GREATER WASH TMZ AIRSPACE CHANGE

STAKEHOLDER CONSULTATION - FEEDBACK Issue 1

Figure 3 TMZ with 2nm buffer around blanked areas (Airspace background)

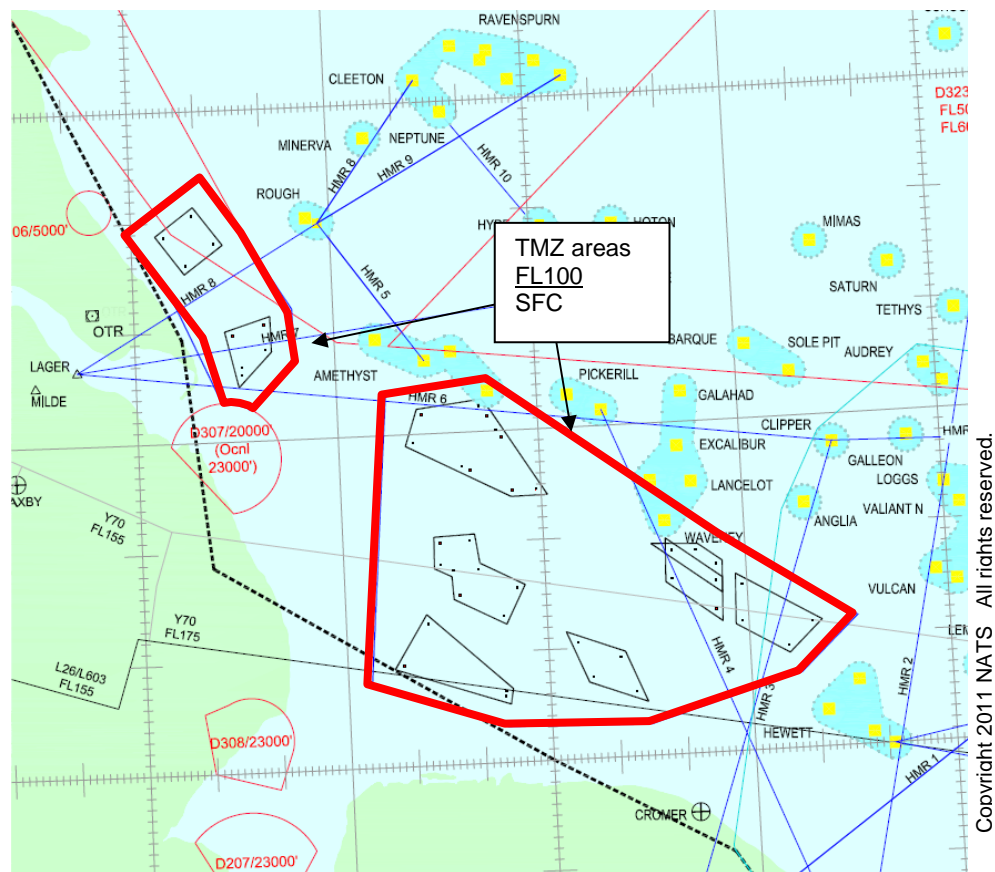
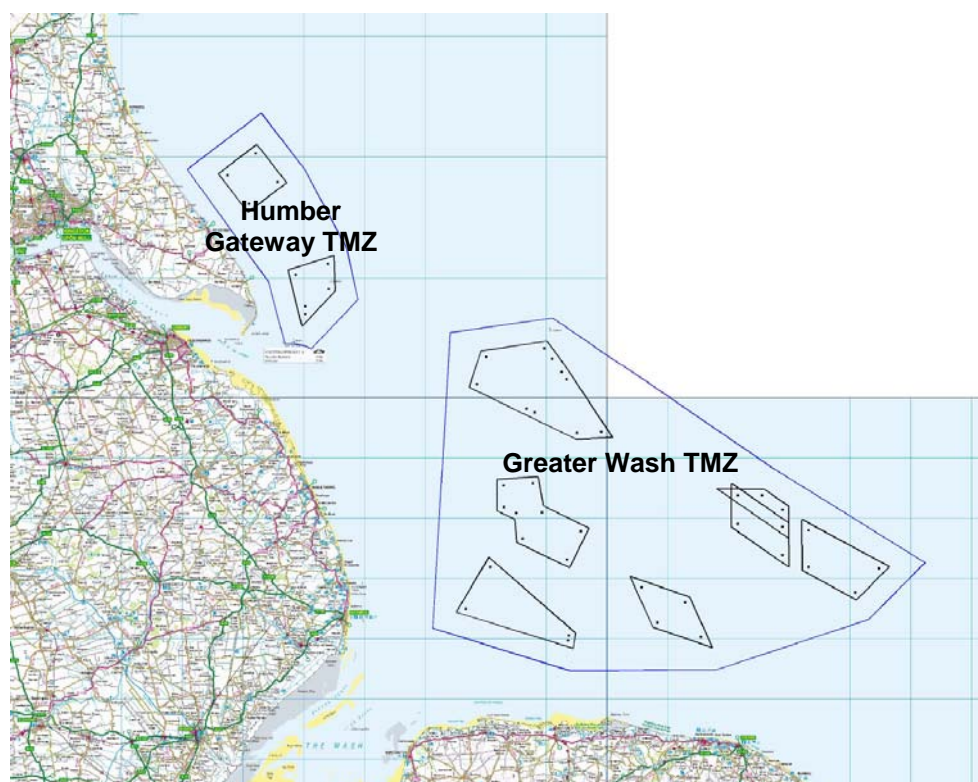
Option 2c in particular would have resulted in the TMZ extending beyond the coastline inland, and hence would have interfered with this practice for non-transponder equipped aircraft. Some stakeholders objected to option 2c on these grounds.

Option 2b will not impinge on the coastline and will leave at least 1.37nm between the coastline and the TMZ at its closest point. Non-transponder equipped aircraft will still be able to use the coastline as a navigational reference, and by following the coast they will automatically be keeping clear of the proposed TMZs.

As a result of careful consideration of all consultation responses, NATS will proceed with an airspace change proposal (ACP) to the CAA. The basis of this proposal will be for the introduction of 2 new TMZs as per Option 2b (2nm buffer), as shown in Figure 3. The proposed TMZ will extend from the surface to FL100. The TMZ with 2nm buffer strikes the best balance between the competing needs of the ATC requirement for a buffer around the blanked areas, and the GA community's desire for TMZs to be as small as practical, and not to impinge on the coastline.

This solution will allow non-transponder equipped GA aircraft to continue to fly along the coastline. This option is also acceptable to the MoD (subject to certain requirements described in the ACP).
